1 **Below are substantive changes to PCI 135, Specification for Tolerances of Precast Concrete,**  
2 **due to public comments. Changes are shown in redline/strikethrough format. Only these**  
3 **sections of the proposed document as available for a thirty-day public comment period.**

159 **4.3.2**

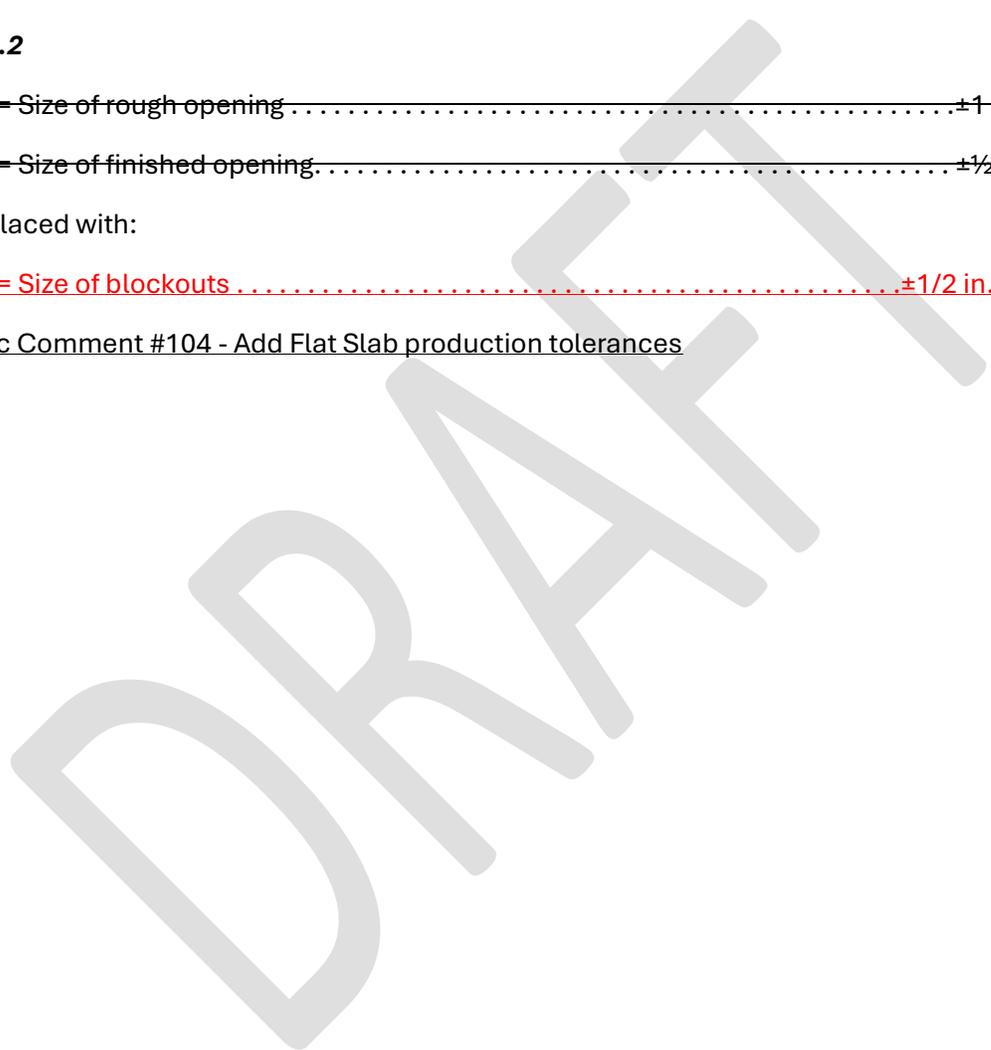
158 Public Comment #97

160 *n*<sub>2</sub> = Size of rough opening . . . . . ±1 in. (±25 mm)

161 *n*<sub>3</sub> = Size of finished opening . . . . . ±½ in. (±13 mm)

162 replaced with:

163 *n*<sub>2</sub> = Size of blockouts . . . . . **±1/2 in. (±13 mm)**

Figure 4.3.6. Flat slab.

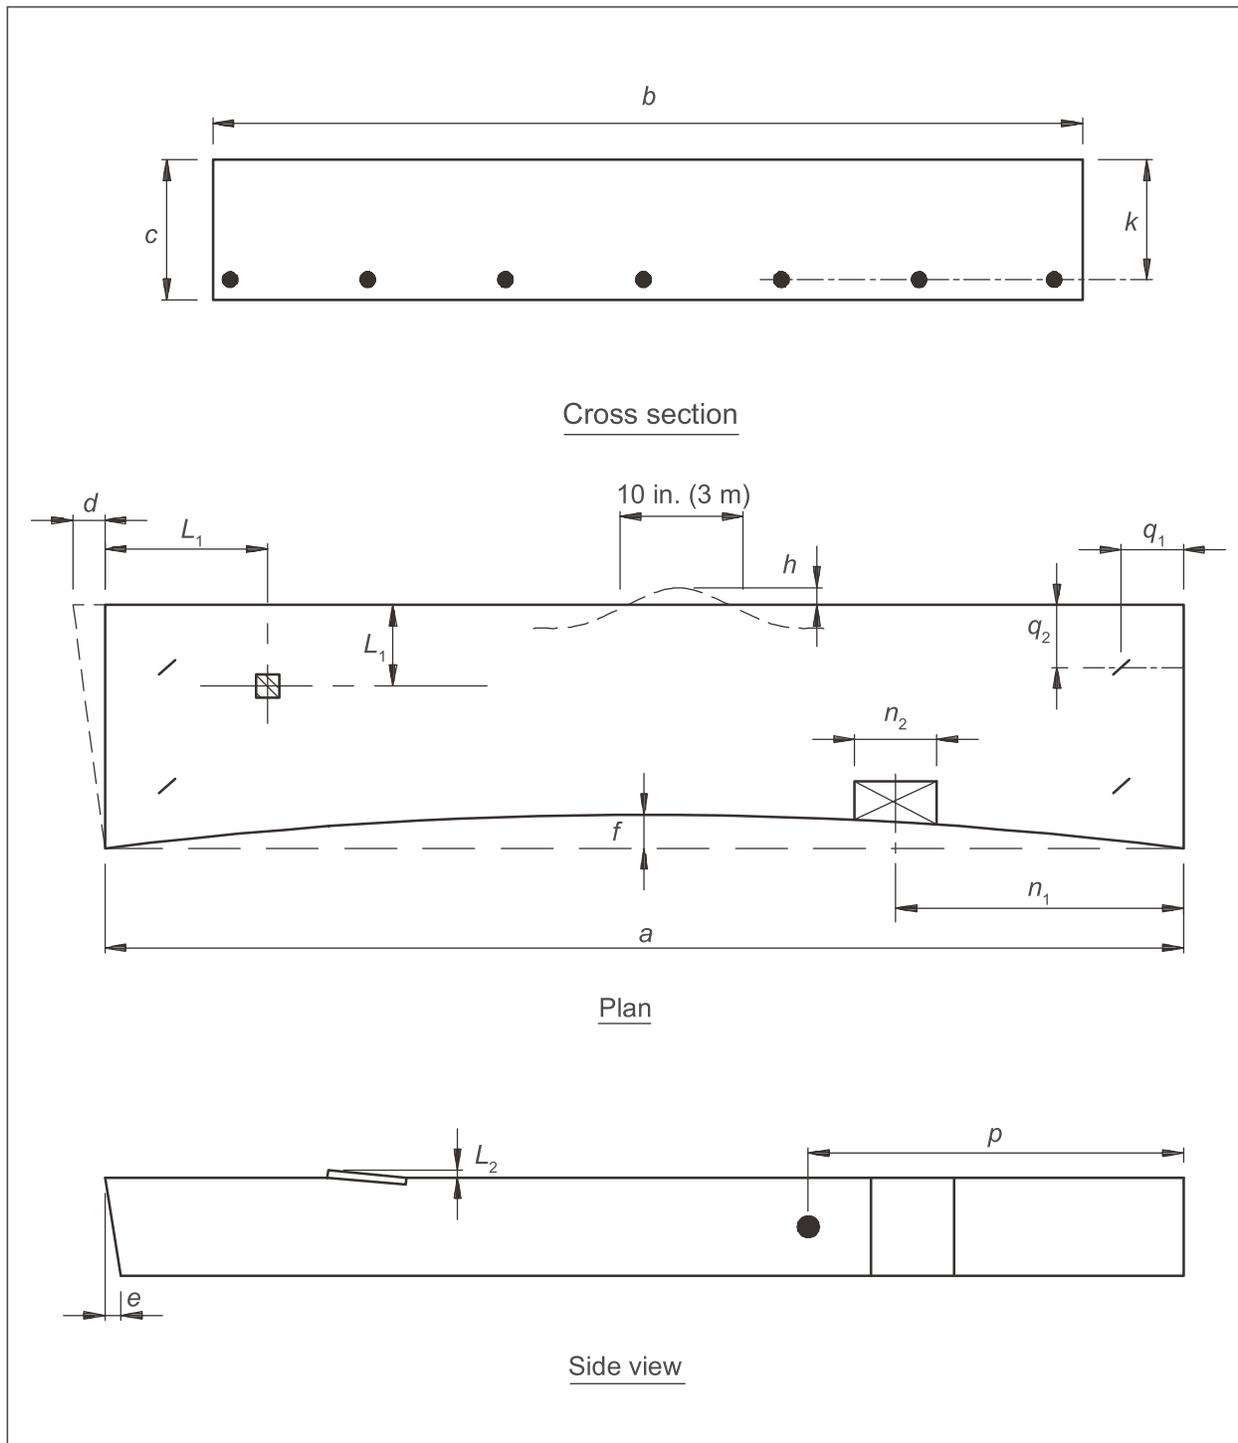
164 Public Comment #104 - Add Flat Slab production tolerances

4.3.6 Fabricate precast concrete solid flat slabs (Fig. 4.3.6) to the following production tolerances:

- a = Length .....  $\pm\frac{1}{2}$  in. ( $\pm 13$  mm)
- b = Width (overall) .....  $\pm\frac{1}{4}$  in. ( $\pm 6$  mm)
- c = Depth (overall) .....  $\pm\frac{1}{4}$  in. ( $\pm 6$  mm)

- $d$  = Variation from specified plan end squareness or skew  
 .....  $\pm\frac{1}{4}$  in. per 12 in. width;  $\pm\frac{1}{2}$  in. maximum  
 ( $\pm 6$  mm per 300 mm width;  $\pm 13$  mm maximum)

- $e$  = Variation from specified elevation end squareness or skew .....  $\pm\frac{1}{4}$  in. ( $\pm 6$  mm)
- $f$  = Sweep, for component length:  
 Component length  $\leq 40$  ft ( $\leq 12$  m) .....  $\frac{1}{4}$  in. (6 mm)  
 Component length  $> 40$  to 60 ft ( $> 12$  to 18 m) .....  $\frac{3}{8}$  in. (10 mm)

- $g$  = Camber variation from design camber .....  $\pm\frac{1}{4}$  in/ per 10 ft;  
 ( $\pm\frac{3}{4}$  in. maximum ( $\pm 6$  mm per 3 m;  $\pm 19$  mm maximum)

- $g_1$  = Differential camber between adjacent untopped components of the same design to receive topping  
 .....  $\frac{1}{4}$  in. per 10 ft;  $\frac{3}{4}$  in. maximum  
 (6 mm per 3 m; 19 mm maximum)

- $g_2$  = Differential camber between adjacent pretopped components of the same design  
 .....  $\frac{1}{8}$  in. per 10 ft;  $\frac{3}{8}$  in. maximum  
 (3 mm per 3 m; 10 mm maximum)

- $h$  = Local smoothness of any surface .....  $\frac{1}{4}$  in. per 10 ft (6 mm per 3 m)
- $k$  = Location of reinforcing material .....  $\pm\frac{1}{4}$  in. ( $\pm 6$  mm)

- $L_1$  = Location of embedment .....  $\pm 1$  in. ( $\pm 25$  mm)
- $L_2$  = Tipping and flushness of embedment .....  $\pm\frac{1}{4}$  in. ( $\pm 6$  mm)

- $n_1$  = Location of blockout .....  $\pm 1$  in. ( $\pm 25$  mm)
- $n_2$  = Size of blockouts .....  $\pm\frac{1}{2}$  in. ( $\pm 13$  mm)
- $p$  = Location of inserts for structural connections .....  $\pm\frac{1}{2}$  in. ( $\pm 13$  mm)

- $q_1$  = Location of handling device parallel to length of component .....  $\pm 6$  in. ( $\pm 150$  mm)
- $q_2$  = Location of handling device transverse to length of component .....  $\pm 1$  in. ( $\pm 25$  mm)

Figure 5.3.4. Architectural wall panel or spandrel erection tolerances.

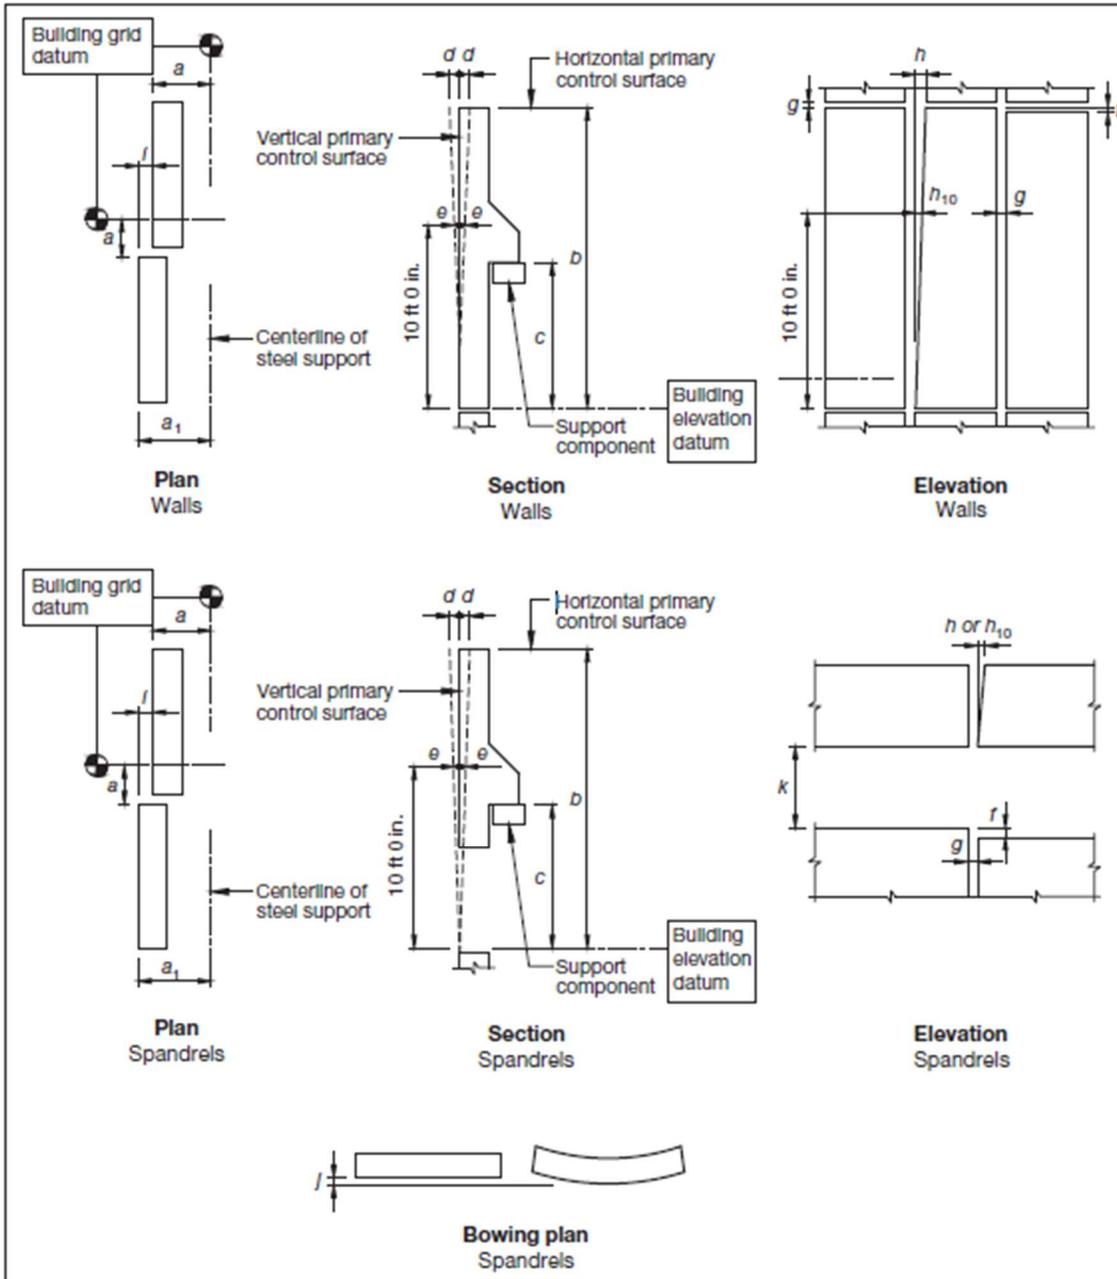
201 Public Comment #162 - match figures in MNL 117. Also reference Fig. 5.4.1

Add note at bottom of fig. 2034: See Fig. 5.4.1 for GFRG panel erection tolerances.
